ATTACHMENT 4: COUNCIL RESPONSE TO APPLICANT'S LETTER TO LPP (17/2/2026)

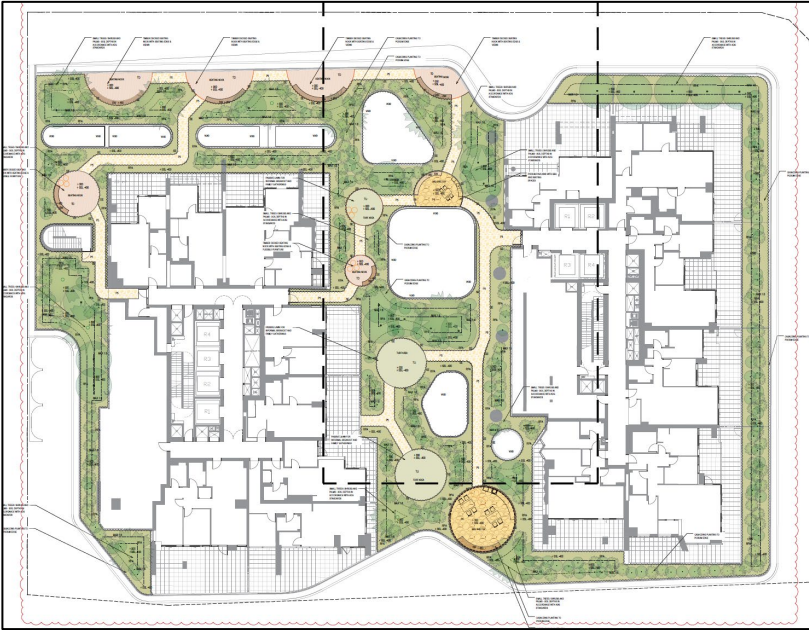
121	Amendment to Condition 121 - Landscaping Plan The final Landscape Plans must be consistent with rev 03 plans dated 07.09.2023 listed in Condition 1 and prepared by LANDFORM Studios together with any additional criteria required by the Development Consent to the satisfaction of the Certifying Authority addressing the following requirements:	Not support - Design excellence was predicated on provision of a high standard of landscape on the podium in format that was integrated into the design of the building (refer approved Landscaping Plan - Level 3 below).

Condition #	Applicant request (in red)	Council Officer response
	k) Trees are to be relocated northwards slightly, to ensure there is adequate canopy clearance (no clash) with the building over-hang above. l) A tree pit detail is required for the trees within the planters. To ensure the soil volume is contiguous and continues under the paving and within the adjacent landscape areas, a structural pavement system is required such as a suspended concrete slab or structural / modular cells within the paved area to mitigate against soil compaction and to maximise aeration and porosity in the tree root zone. The base of the tree pit shall incorporate a drainage layer and pipe that connects to nearest stormwater pit. Podium a) Demonstrate that the design meets the Apartment Design Guidelines (ADG) minimum soil requirements for the trees for all podium levels. Soil volume, depth and soil area must meet the following prescribed standards in the Apartment Design Guide (ADG) – Part 4, 4P <i>Planting on Structures - Tools for improving the design of residential apartment development</i> (NSW Department of Planning and Environment, 2015). b) Provide a soil plan for each level showing the m3 soil volume and soil depth to show that the ADG soil requirements have been met on all podium levels and shows soil continues below the paving areas. c) Details are to be coordinated with the updated architectural sections to show that the landscape aspect of the design works with the proposed architectural elements. d) The relationship of the planting /soil profile, podium edge and the balustrade is unclear. Provide a series of specific detailed sections through the different	 Approved Landscape Plan – Level 3 (DA/93/2023)
